SIB 33 04 21 DRIVE CHAIN CONTACTS SWING ARM

2021-06-08

Model	Model Description	Production Date
K69	S 1000 XR	To May 31, 2021

Figure 2: Installation location of chain guard

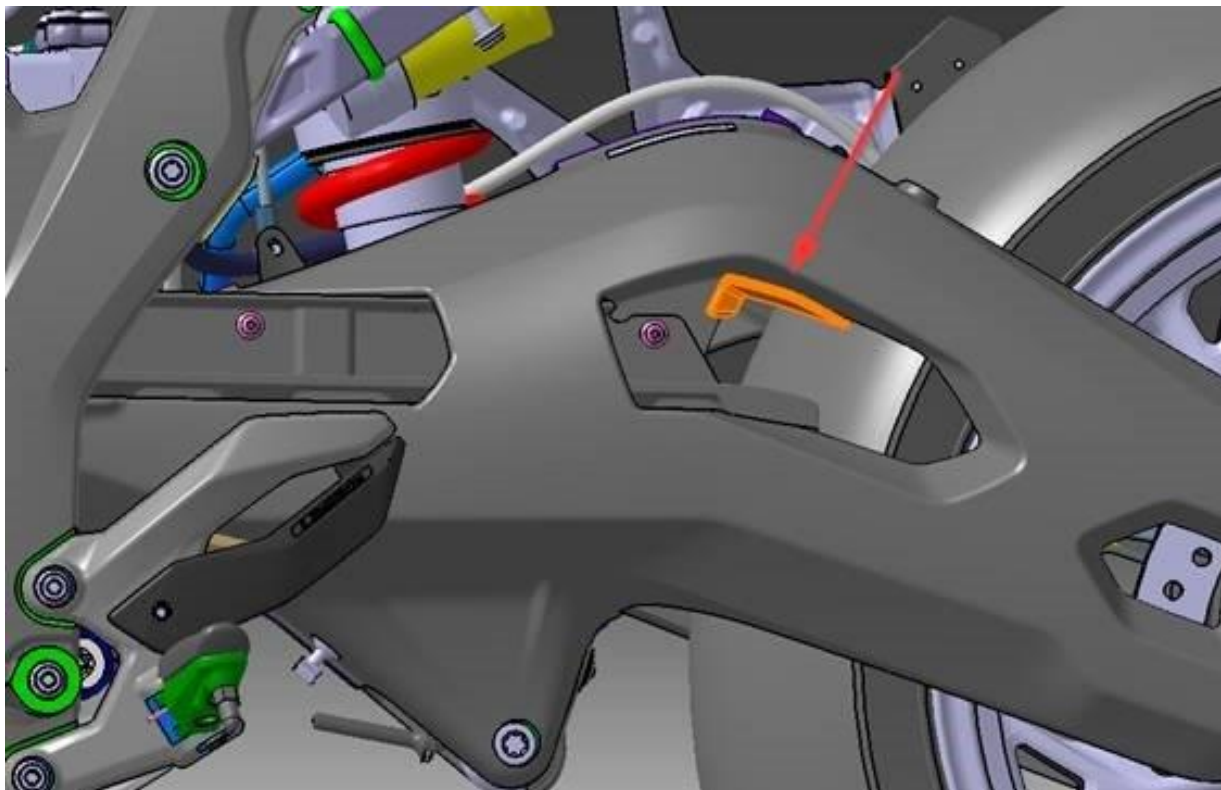
Depending on the chassis and suspension adjustment, as well as vehicle load, the drive chain may make contact with the swing arm under certain conditions.

The area to which the guard is applied must be thoroughly cleaned and free of dirt and chain grease. Please refer to the Figure 2 below for the correct attachment of the guard.

As of May 31, 2021, a chain-impact guard is installed at the factory.

For vehicles built before May 31, 2021, the chain impact guard can be retrofitted under warranty in the event of a complaint.

Please note, that a new impact guard must be installed any time the swing arm is replaced.

Figure 2: Installation location of chain guard

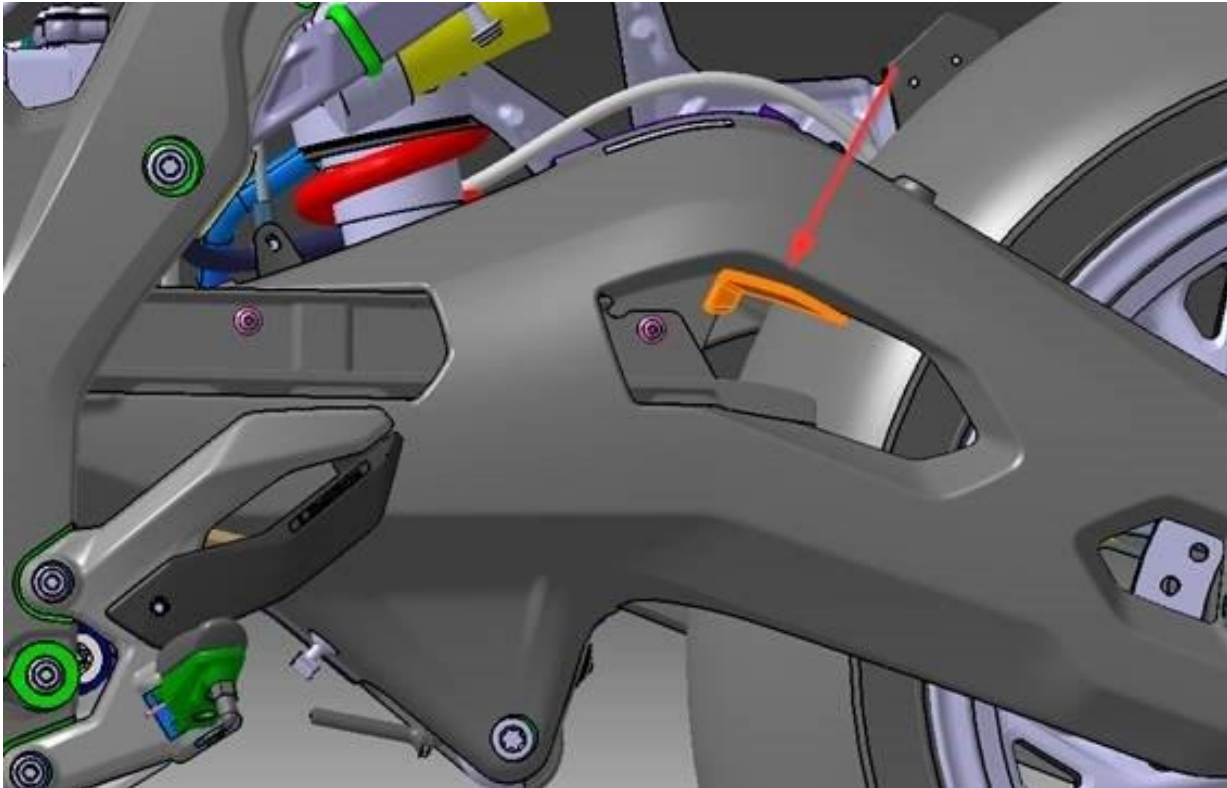
Depending on the chassis and suspension adjustment, as well as vehicle load, the drive chain may make contact with the swing arm under certain conditions.

The area to which the guard is applied must be thoroughly cleaned and free of dirt and chain grease. Please refer to the Figure 2 below for the correct attachment of the guard.

As of May 31, 2021, a chain-impact guard is installed at the factory.

For vehicles built before May 31, 2021, the chain impact guard can be retrofitted under warranty in the event of a complaint.

Please note, that a new impact guard must be installed any time the swing arm is replaced.
